Rebuttal Report of Christian R. Petrich

In the Matter of Application for Transfer No. 73811 (Shekinah Industries); Application for Transfer No. 73834 (Orchard Ranch); Application for Permit No. 63-32499 (Mayfield Townsite); Application for Permit No. 61-12095 (Nevid-Corder); Application for Permit No. 61-12096 (Nevid); Application for Permit No. 63-32703 (Orchard Ranch); Application for Permit No. 61-12256 (Intermountain Sewer & Water); Application for Permit No. 63-33344 (ARK Properties-Mayfield Townsite) before the Idaho Department of Water Resources

January 30, 2013

Figure 12. Snake River minimum flows.

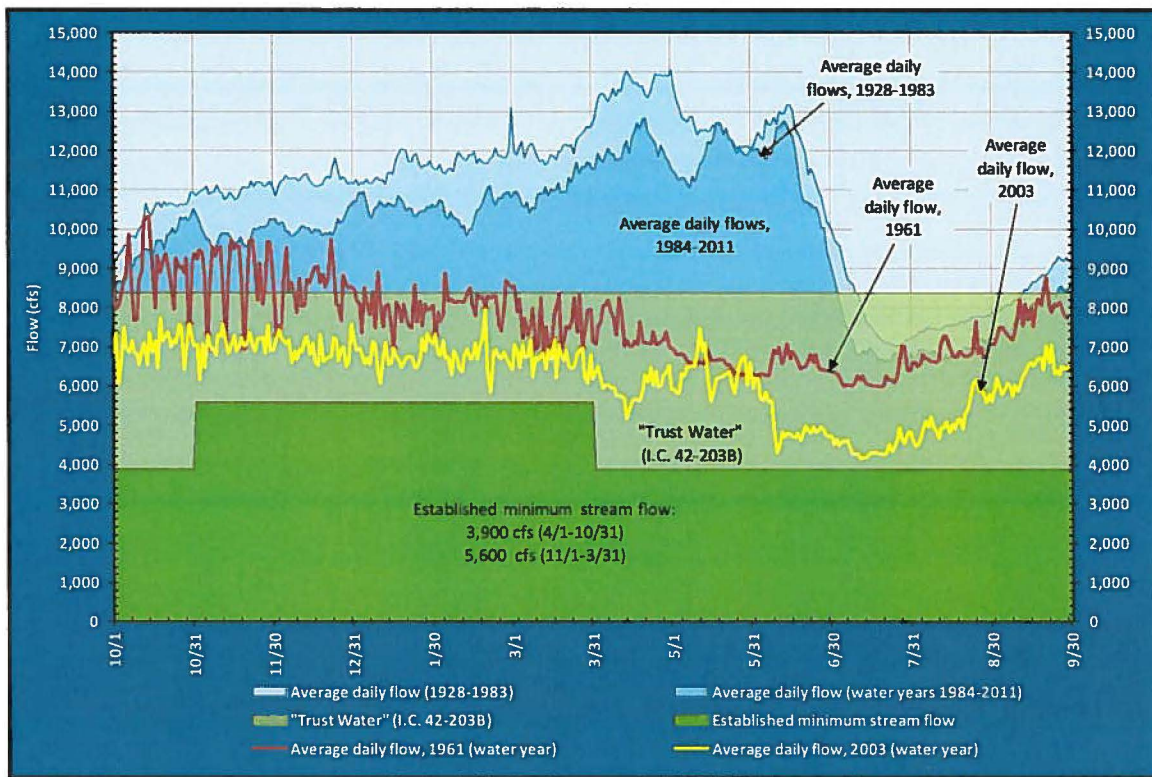
18. *ERO implies with its flow characterizations (ERO Report, pages 22-27) that approval of pending consolidated-case applications will cause declines in Snake River flows, thereby injuring (or contributing to injury of) existing Idaho Power water rights.*

It is important to recognize that average Snake River flows remain well above established minimums. Average daily flows since 1984 (Figure 12) have not only been greater than established minimum flows, but during substantial portions of the year have been greater than the 8,400-cfs generating capacity at Swan Falls Dam. Approval of consolidated-case applications and transfers would represent absolutely no impact to hydroelectric generation during times of the flows greater than 8,400 cfs.

Recent low-flow years (e.g. 2003 – see Figure 12) have seen average daily flows less than 8,400 cfs (but more than minimum flows). However, hydropower rights

Based on the hydrographs in Figure 12, it appears unlikely that a future dip below established minimum flows, if it occurs, would have a long duration. Non-approval of the proposed consolidated-case applications and transfers because Snake River flows may dip below established minimums for a short period of time sometime in the future would preclude the full economic development of the study-area groundwater resource as provided under Idaho Code § 42-226. Furthermore, attempting to prevent a dip in minimum flows by disapproval of these consolidated applications and transfers would be futile because of the relatively small amount of water involved¹⁴.
